MAINE TURNPIKE AUTHORITY

ADDENDUM NO. 1

CONTRACT 2019.11

**NORTHERN BRIDGE REPAIRS, 6 LOCATIONS AND
EMERGENCY VEHICLE RAMPS AND
NEW GLOUCESTER TOLL PLAZA REHABILITATION
MILE 62.3 TO 95.6**

NORTHERN BRIDGE REPAIRS &
BENNETT ROAD EMERGENCY VEHICLE RAMPS
BENNETT ROAD EVR (MILE 68.6)
TYPICAL SECTIONS SHEET 1 OF 2

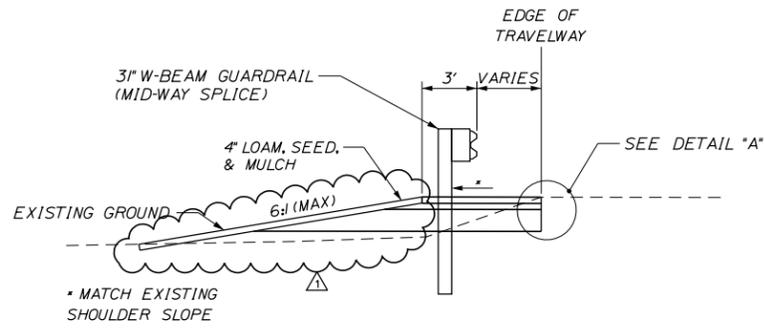
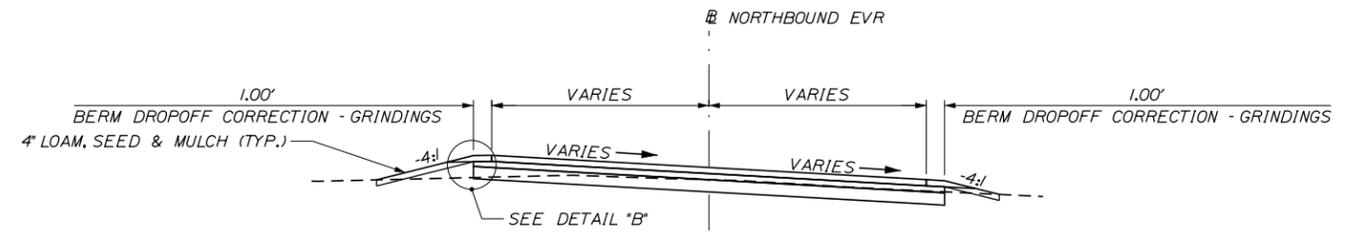
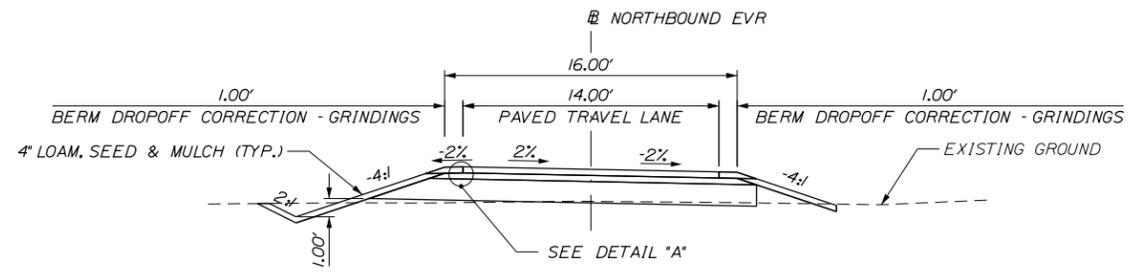
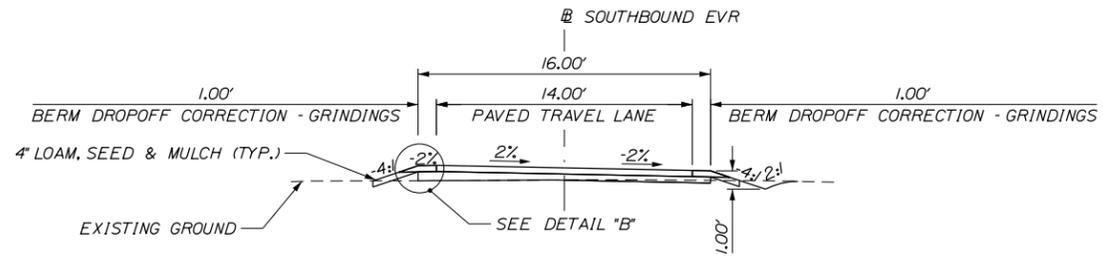
Plan Sheets 10 and 11 of 105, “Bennett Road EVR (Mile 68.6) Typical Sections” are deleted and replaced in their entirety with the attached revised sheets 10 and 11.

SHEET NUMBER: DET-01

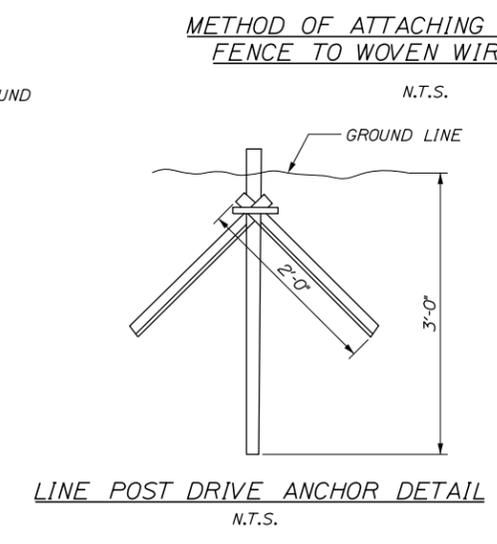
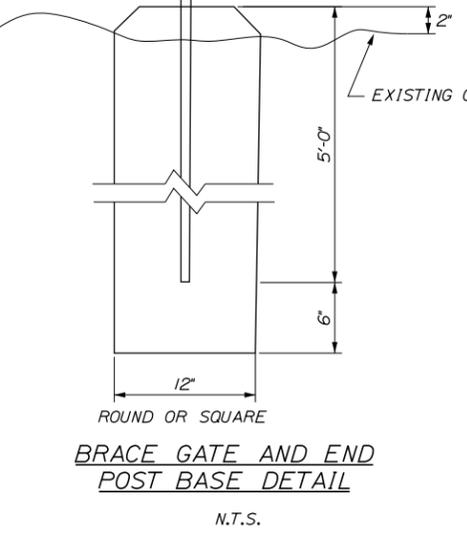
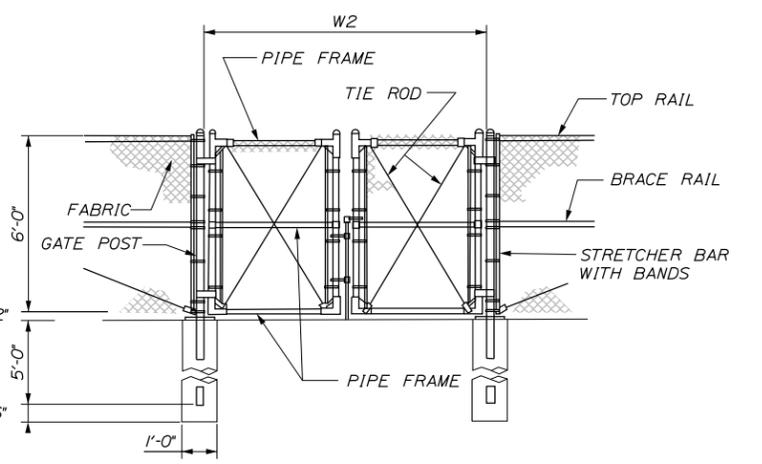
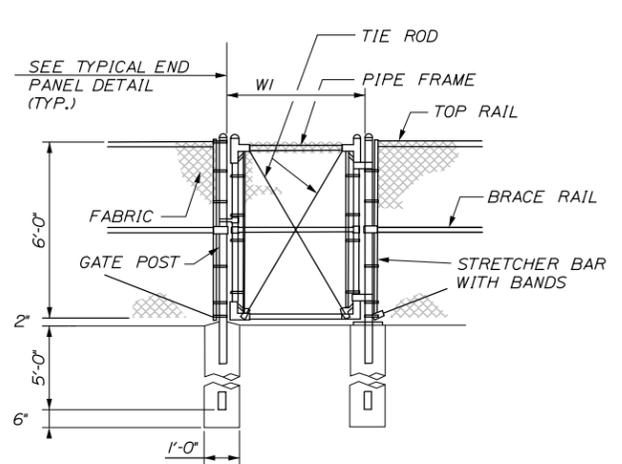
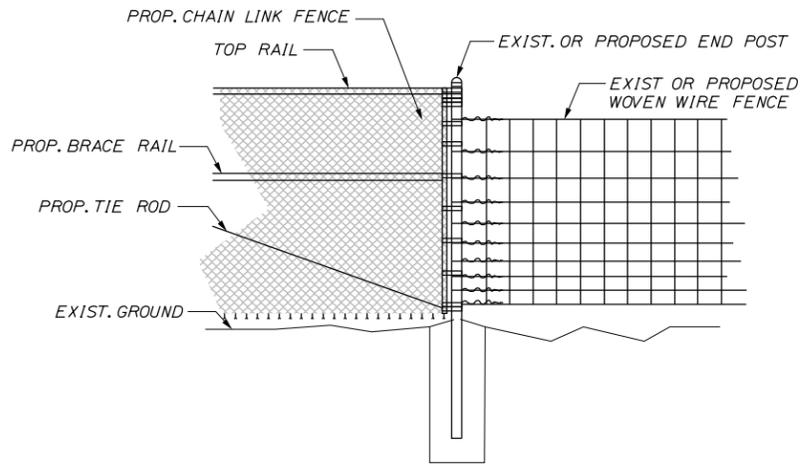
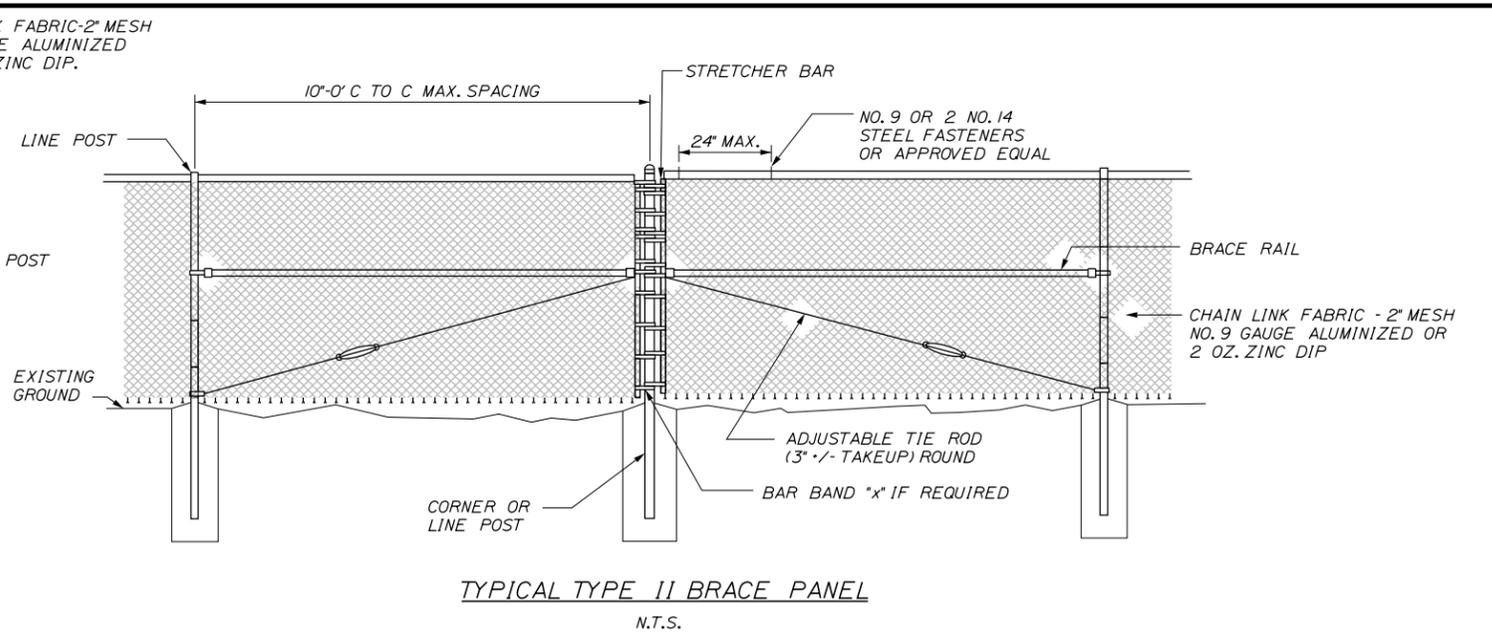
Question 2: Note No. 8 on Plan Sheet 97 calls for PVC Privacy Slats to be installed as noted on the plans. I don’t see any notes on the plans for PVC Privacy Slats.

- ALL COMPONENTS OF CHAIN LINK FENCE SHALL BE IN ACCORDANCE WITH AASHTO M181.
- PVC PRIVACY SLATS SHALL BE INSTALLED AS NOTED ON THE PLANS AND SHALL CONFORM TO THE REQUIREMENTS OF SPECIAL PROVISION SECTION 607 FENCES OF THE PROJECT SPECIFICATIONS.

Answer: This note has been deleted. No PVC privacy slats are required for this project.

No.	Revision	By	Date
1	Delete Note 9	DSM	3/19
